ANGLICAN
RETIREMENT
VILLAGES
DIOCESE OF SYDNEY

RE: MODIFICATIONS TO MAJOR PROJECT (MP 06_0094) – CONCEPT PLAN FOR THE ANGLICAN RETIREMENT VILLAGE, SANDON POINT

This letter is submitted under Division 5 of Part 3A of the Environmental Planning and Assessment Act 1979 to request the Minister for Planning to modify the approval of the concept plan prepared by the Anglican Retirement Villages (ARV) for Sandon Point.

ARV BULLI RETIREMENT VILLAGE: STURDEE AVENUE BULLI COOKSON'S CREEK CORRIDOR CROSS SECTION 1:200 PROPOSED MODIFICATION

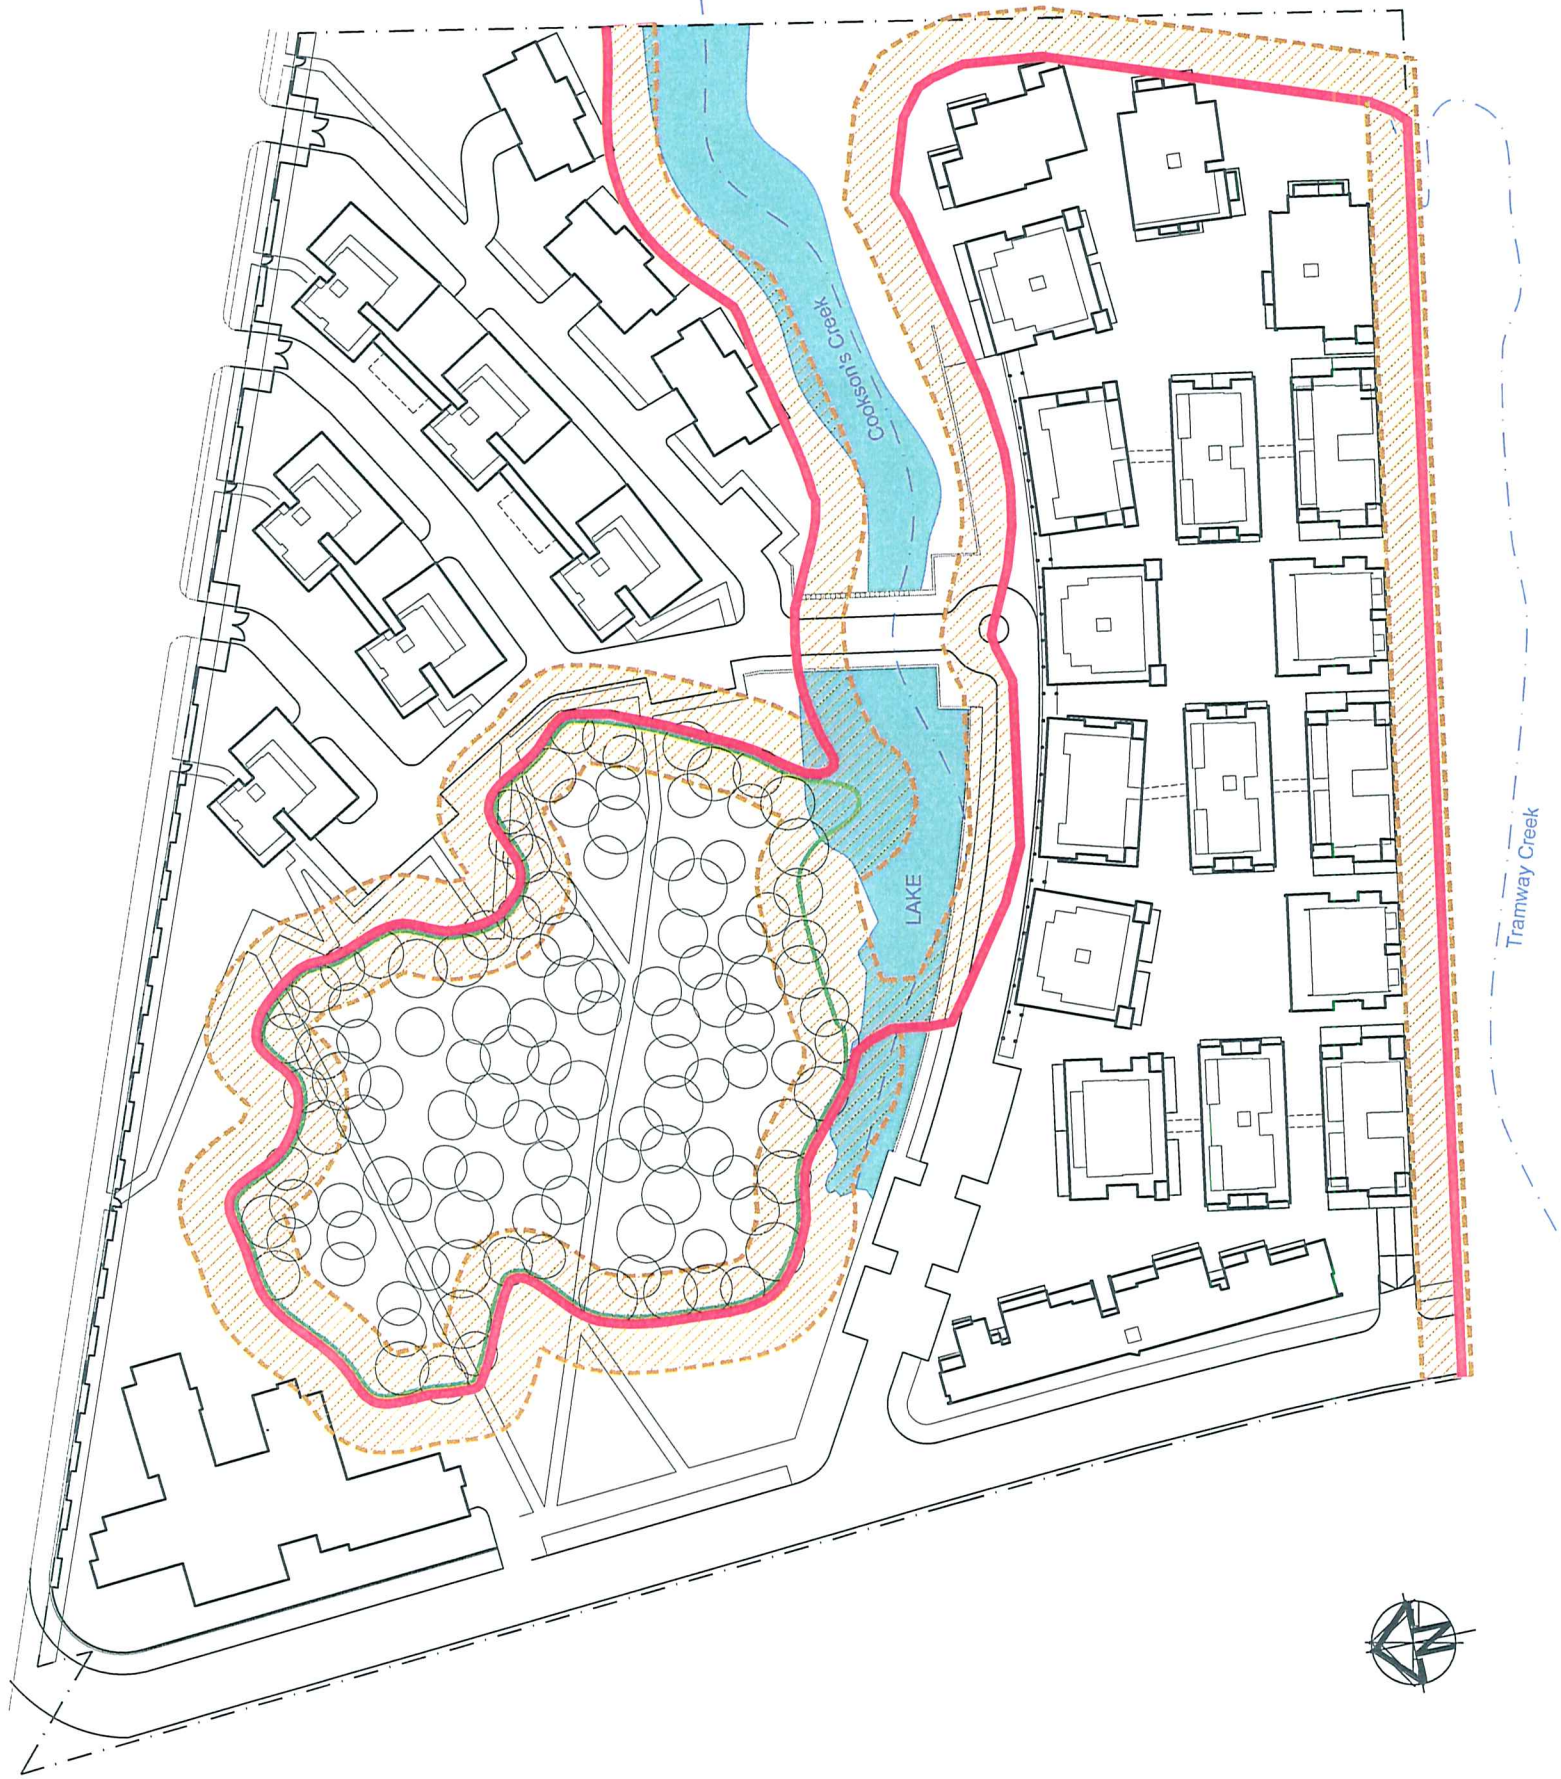
(Cumberland Ecology 2006). This is demonstrated in the Cookson's Creek Corridor Cross Section, Proposed Modification Plan, prepared by the landscape architect Craig Burton & Associates and provided in the Appendix to this letter.

The vegetation communities at Sandon Point are restricted to narrow strips on alluvial soils and do not naturally occur as wide bands of vegetation, therefore the 40 metre riparian zone to be re-established for Cookson's Creek and 50 metre riparian zone for Tramway creek is more than adequate to provide for the protection and enhancement of the future riparian vegetation and as a habitat corridor. This is supported by the fact that both creeks conform to the Riparian Corridor Management Study by the Department of Natural Resources (DNR), as Category 2 Streams, for which a 40 metre wide riparian corridor is recommended. This consists of a 20 metre wide core riparian zone and 10 metre buffer either side of this creek zone, as shown in the Cookson's Creek Corridor Cross Section Plan.

The creation of an APZ in the outer 10 metres of the riparian zone will not impede on revegetation works as the replanted vegetation will still contribute to the function of the ecological corridor. As shown in the Cookson's Creek Corridor Cross Section, the outer 10 metres of the riparian zone will contain native indigenous trees and shrubs representative of the EEC vegetation, therefore adding value to the corridor.

The Cookson's Creek riparian zone is proposed to have a 10 m APZ within the outer 10 m of the 40m corridor, leaving an inner 20 m corridor to be rehabilitated with indigenous wetland species. The attached Cookson's Creek Corridor Cross Section, Proposed Modification Plan, prepared by the landscape architect Craig Burton & Associates illustrates the concept of the APZ and riparian corridor.
